Report of 3rd Pilot audit of Transmission Tower by the audit team of the committee for Audit of Transmission Tower

Figure 2. Buckled member

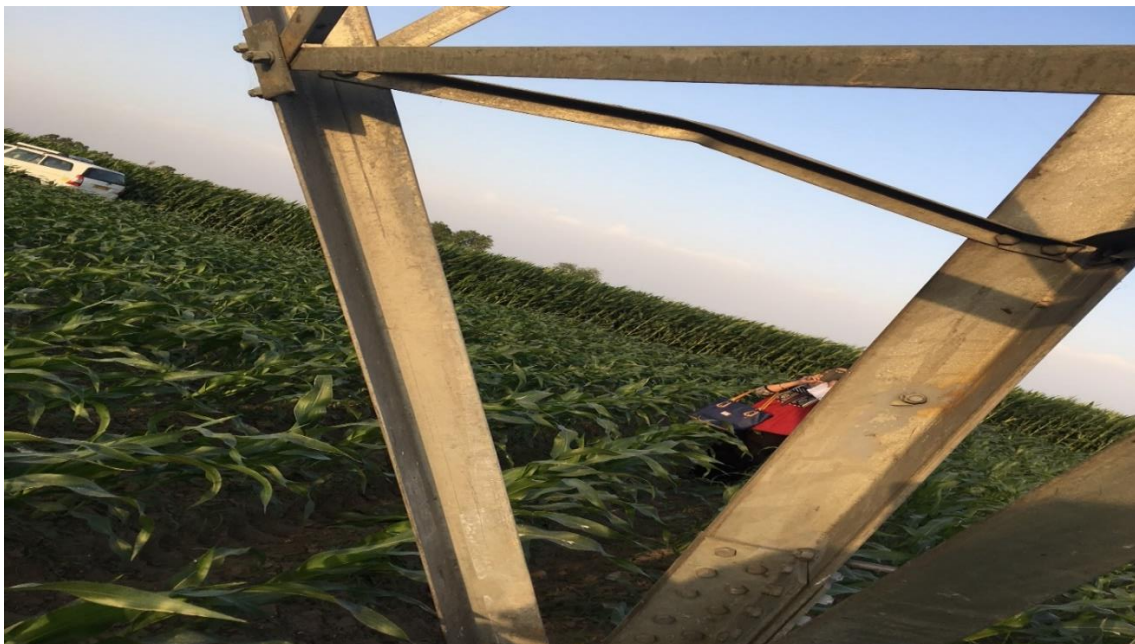
Observation & Conclusion: Buckling of a secondary member in tower no. 20, Anti climbing devices (ACD) were found partially damaged in the tower no. 15 & 20 of 400 kV Jalandhar-Sambha D/C Transmission Line. Anti-climbing device was absent in the tower no. 91/3 & 94/0 of 400 kV Malerkotla- Amritsar D/C Transmission Line, bending of a member and also step bolts were found below ACD level in all the towers of this line. Moreover, the peak was damaged, bolts were missing & ACD was absent in the tower of 400 kV Agra (PG)-Agra (UP) and a bracing was found to be missing from 765 kV Agra – Jhatikara S/C Transmission Line, details of which can be referred from **Annexure**.

Recommendation: Missing ACD shall be installed, step bolts below ACD shall be removed,

Bent/buckled members to be replaced at the earliest, Dummy bolts, missing step bolts need to be plugged in order to keep the line in healthy condition. Inspection / patrolling of towers to be carried out regularly.
